PIC18F85J90 Family Silicon Errata and Data Sheet Clarification

The PIC18F85J90 family devices that you have received conform functionally to the current Device Data Sheet (DS39770C), except for the anomalies described in this document.

The following typographic corrections and clarifications are to be noted for the latest version of the device data sheet (DS39770C):

FIGURE 2-3 FREQUENCY vs. ESR PERFORMANCE FOR SUGGESTED VCAP

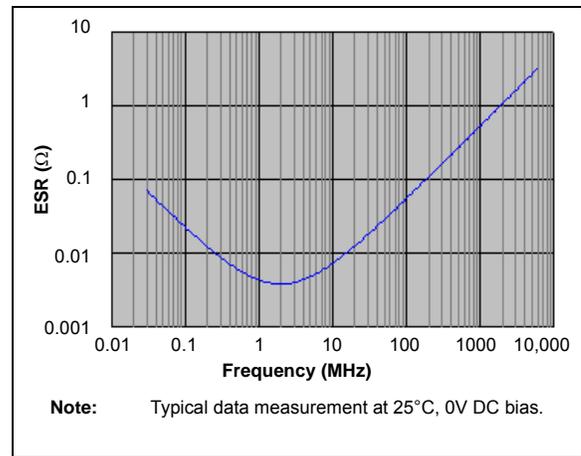
Section 2.4 “Voltage Regulator Pins (ENVREG and VCAP/VDDCORE)” has been replaced with a new and more detailed section. The entire text follows:

When the regulator is enabled, a low-ESR (< 5Ω) capacitor is required on the VCAP/VDDCORE pin to stabilize the voltage regulator output voltage. The VCAP/VDDCORE pin must not be connected to VDD and must use a capacitor of 10 μF connected to ground. The type can be ceramic or tantalum. Suitable examples of capacitors are shown in [Table 2-1](#). Capacitors with equivalent specification can be used.

Designers may use [Figure 2-3](#) to evaluate ESR equivalence of candidate devices.

FIGURE 2-4 DC BIAS VOLTAGE vs. CAPACITANCE CHARACTERISTICS

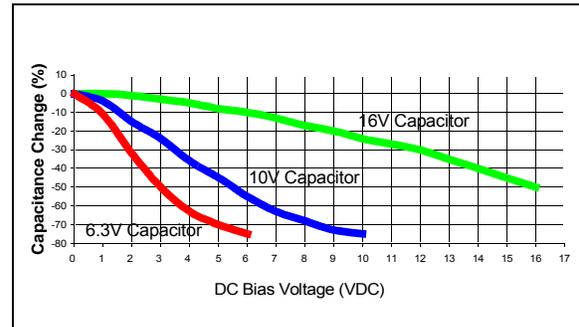
In addition to temperature tolerance, the effective capacitance of large value ceramic capacitors can vary substantially, based on the amount of DC voltage applied to the capacitor. This effect can be very significant, but is often overlooked or is not always documented.

A typical DC bias voltage vs. capacitance graph for X7R type and Y5V type capacitors is shown in Figure 2-4.

When selecting a ceramic capacitor to be used with the VDDCORE voltage regulator, it is suggested to select a high-voltage rating, so that the operating voltage is a small percentage of the maximum rated capacitor voltage. For example, choose a ceramic capacitor rated at 16V for the 2.5V VDDCORE voltage. Suggested capacitors are shown in Table 2-1.
